**Response of CAC and Earthjustice to
the Director’s Draft Report for
the Duke Energy Indiana 2018-19
Integrated Resource Plan**

**Submitted to the IURC on April 7, 2020
Revised April 13, 2020**

**Authors:
Anna Sommer, Energy Futures Group
Chelsea Hotaling, Energy Futures Group
On behalf of Citizens Action Coalition of Indiana (“CAC”)
and Earthjustice**

Figure 2. ICAP and UCAP Comparison of Duke’s Coal Units¹³

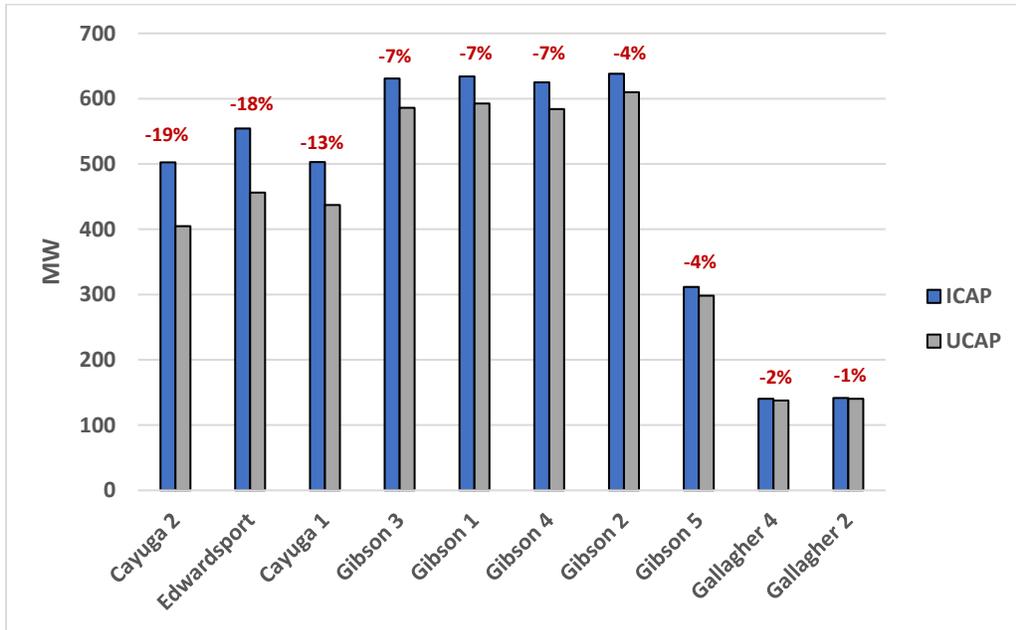
Furthermore, we think it is possible that switching to a UCAP convention might produce a different optimization (when combined with other changes to Duke’s modeling including removing the 15% monthly reserve margin requirement). Figure 2, below, shows the difference between the ICAP and UCAP values for Duke’s coal units based on its response to the 2018 OMS-MISO survey. The percentages above the bars in the graph represent the percentage difference between the ICAP and UCAP values. That difference is not uniform across units. This means that certain units, e.g., Cayuga 1 and 2 and Edwardsport, are much less valuable from a capacity standpoint than is captured by just using each unit’s nameplate rating. The difference in ICAP versus UCAP values is effectively “socialized” across all units by increasing the reserve margin requirement from the UCAP Planning Reserve Margin (PRM) of 7.9%¹² to a value of 15%, which muddies the picture that the IRP can paint of the value of each individual unit.

It is standard practice amongst the MISO utilities we are aware of to model on a UCAP basis. Duke should join in that standard practice.
